CRAY
RESEARCH (UK) LTD

8th August 1985

NOTES ON POWER AND CONTROL WIRING
FOR CRAY SYSTEM - INSPECTED
22ND AND 25TH JULY 1985

NOTES ON CRAY REFRIGERATION PIPEWORK
INSPECTED 25th JULY 1985

4. REF DRAWING V84/347-406/2

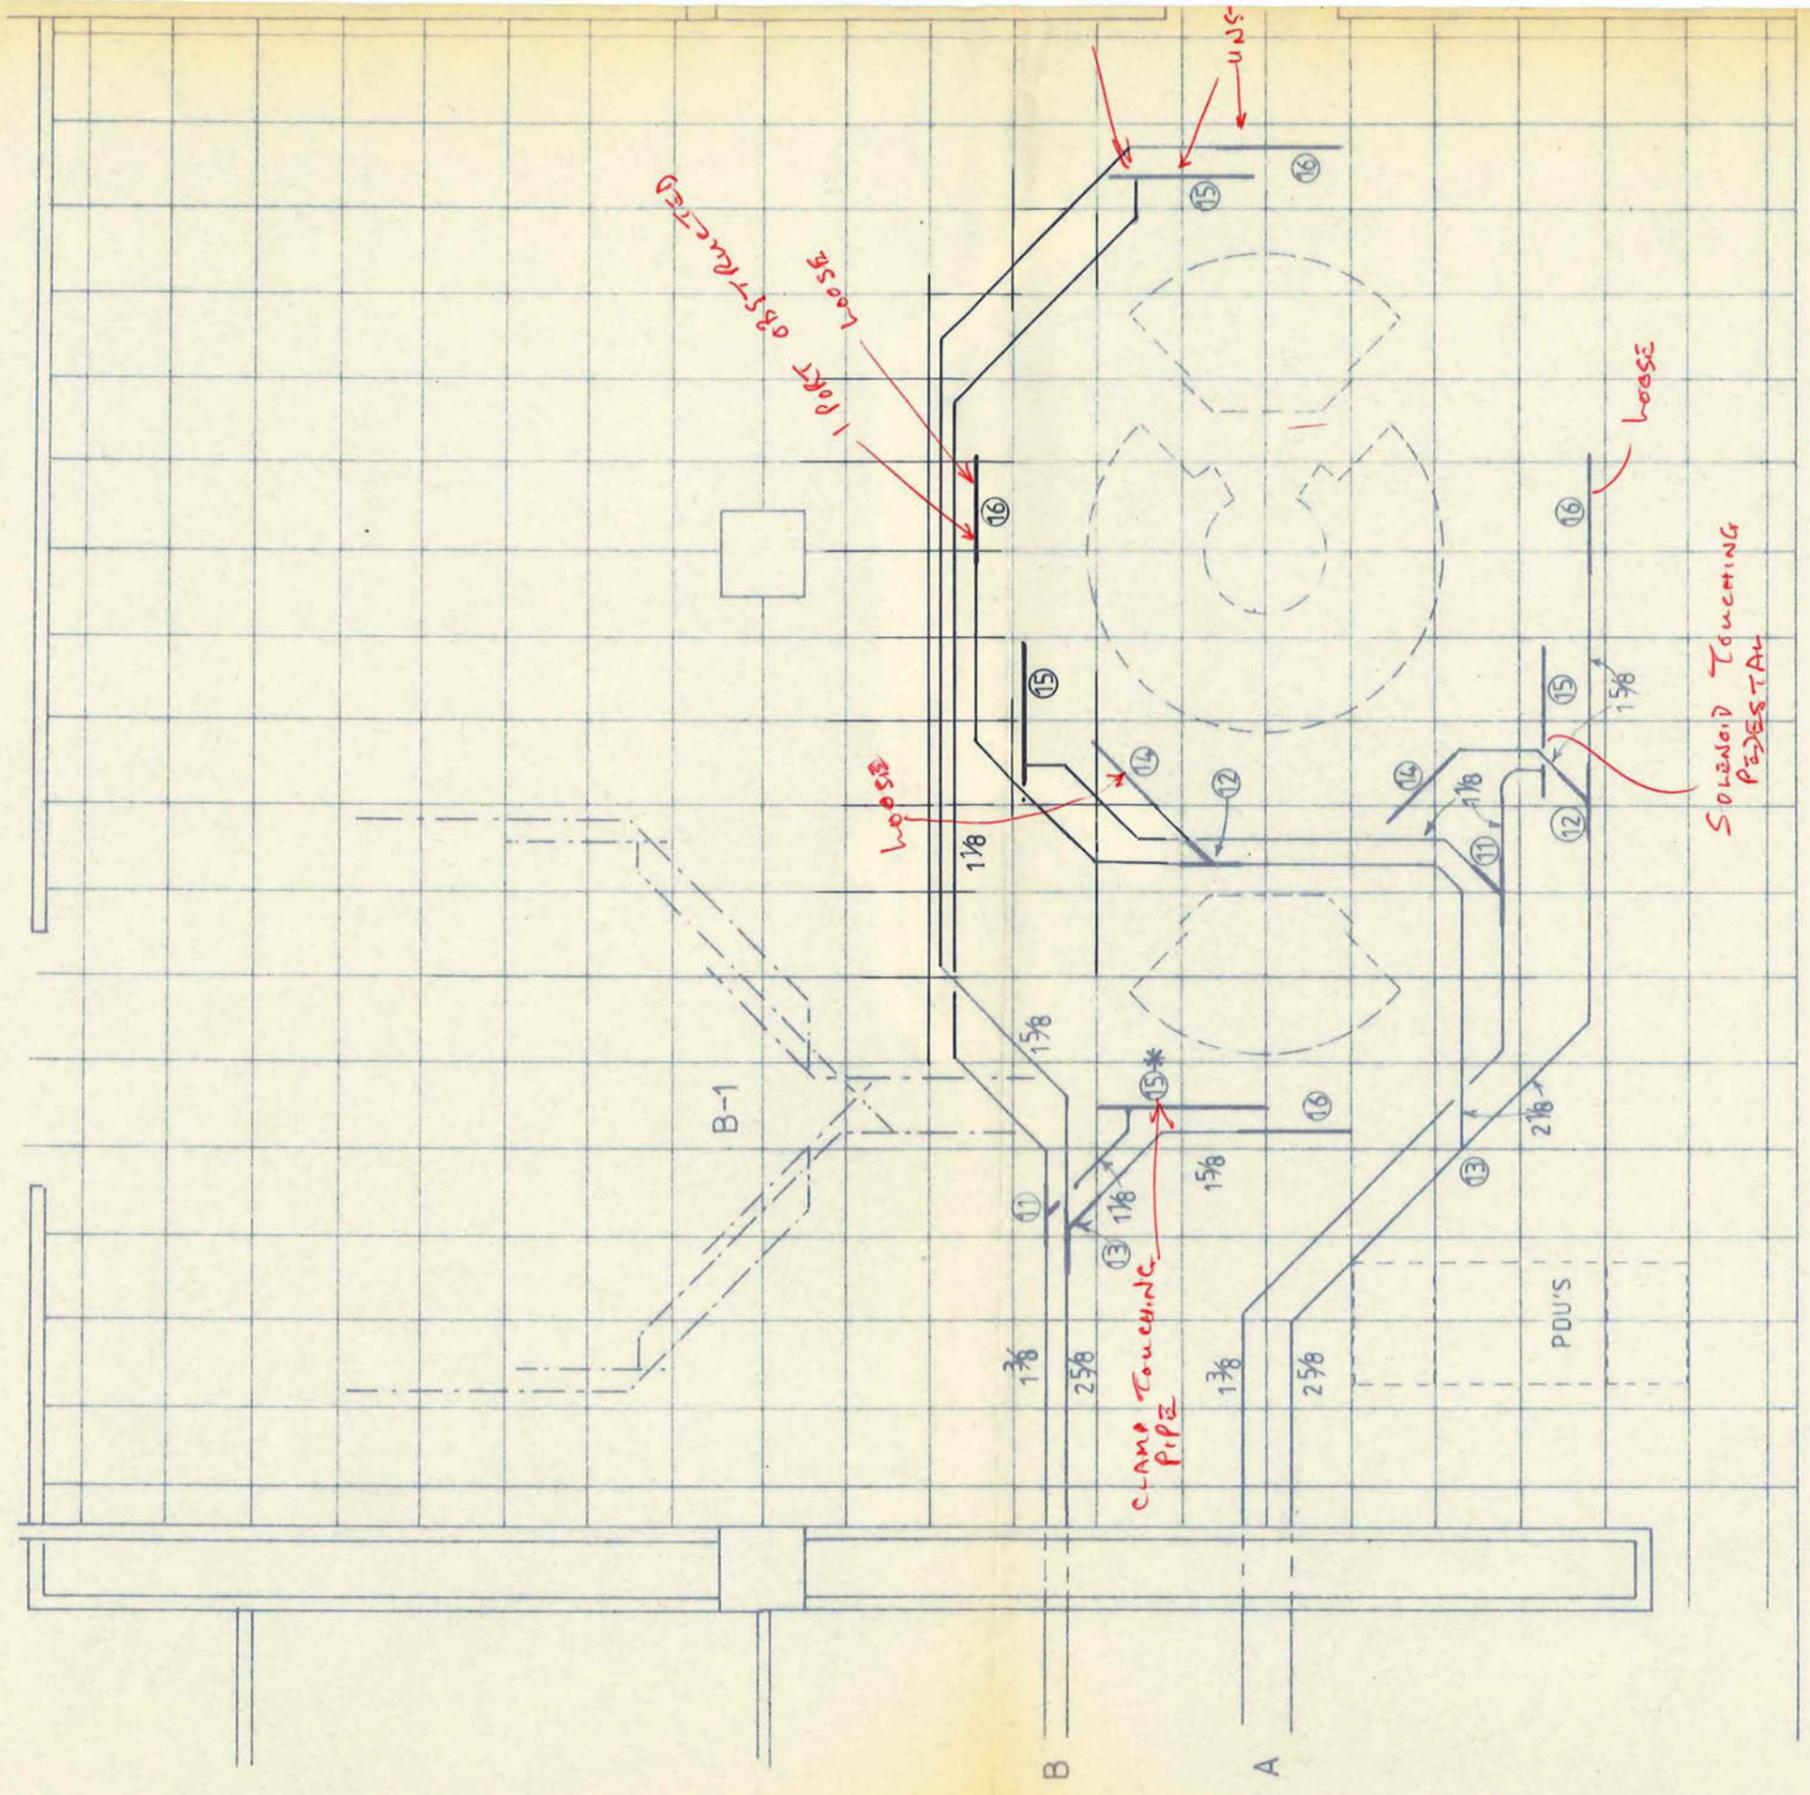
The RCU-1 and the RCU-3 each require 2 60 amp circuits.
(There is an error on the M.U.S. Chart UP4015 which
indicates only one circuit for the RCU-1).

There are no isolators fitted on the RCU's as
delivered. Therefore you will need to fit
isolators close to these units.
